UNITED STATES
DEPARTMENT OF THE INTERIOR
BUREAU OF LAND MANAGEMENTFORM APPROVED
OMB NO. 1004-0137
Expires: January 31, 2018**SUNDRY NOTICES AND REPORTS ON WELLS**
*Do not use this form for proposals to drill or to re-enter an abandoned well. Use form 3160-3 (APD) for such proposals.*5. Lease Serial No.
NMNM03358

☐ Oil Well ☐ Gas Well ☒ Other: COAL BED METHANE8. Well Name and No.
NEBU 492A2. Name of Operator Contact: TOYA COLVIN
BP AMERICA PRODUCTION COMPANY Mail: Toya.Colvin@bp.com9. API Well No.
30-045-33099-00-S13a. Address
380 AIRPORT RD
DURANGO, CO 813033b. Phone No. (include area code)
Ph: 281.892.536910. Field and Pool or Exploratory Area
BASIN FRUITLAND COAL

PLUG AND ABANDONMENT PROCEDURE

CONDITIONS OF APPROVAL

Proposed P&A

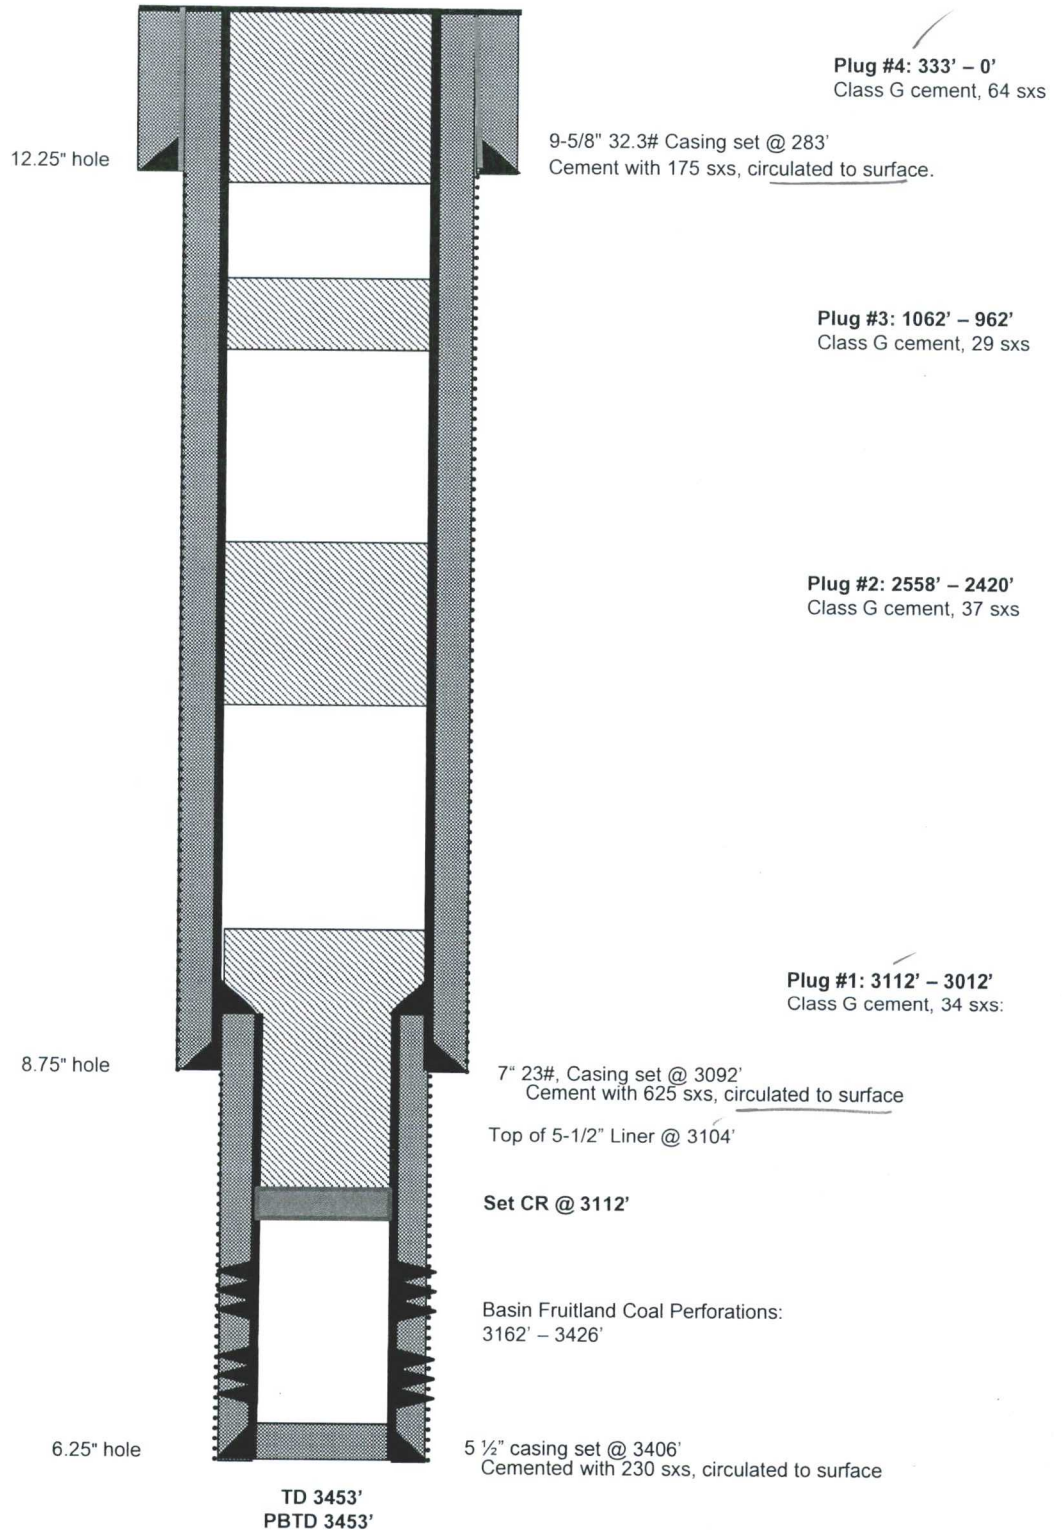
1. Plugging operations authorized are subject to the attached "General Requirements for Permanent Abandonment of Wells on Federal and Indian Lease."
2. Farmington Office is to be notified at least 24 hours before the plugging operations commence (505) 564-7750.
3. The following modifications to your plugging program are to be made:
 - a) Set Plug 1 (3112 – 2993) ft. to cover the Fruitland top. BLM picks top of Fruitland at 3043 ft.
 - b) Set Plug 2 (2593 – 2370) ft. to cover the Kirtland and Ojo Alamo tops. BLM picks top of Kirtland at 2543 ft. BLM picks top of Ojo Alamo at 2420 ft.
 - c) Set Plug 3 (952 – 852) ft. to cover the Nacimiento top. BLM picks top of Nacimiento at 902 ft.

You are also required to place cement excesses per 4.2 and 4.4 of the attached General Requirements.
